UNITED STATES PATENT AND TRADEMARK OFFICE

APPLICATION NO.	FILING DATE	FIRST NAMED INVENTOR	ATTORNEY DOCKET NO.	CONFIRMATION NO.
09/998,972	10/31/2001	Christopher Rogers	DEP 0639	6510

Office Action Summary

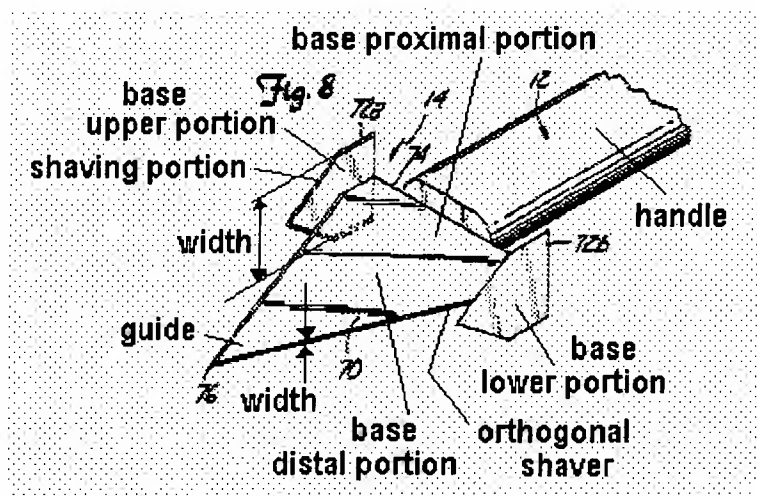
Claims 1-12, 15, 18, 22-24 and 38-44 are rejected under 35 U.S.C. 102(a) as being anticipated by Ray et al (US 5,649,945).

Note the identified structure in Ray et al Figure 8. The intent by applicant that tool be used with base upper and lower portions in a horizontal position rather than a vertical position, fails to provide for any objectively ascertainable structural distinctions between the claimed device and that disclosed by Ray et al.

In regard to claim 4, note the optional handle of Figure 9. In regard to claim 5, note the retraction means 28 (recess).
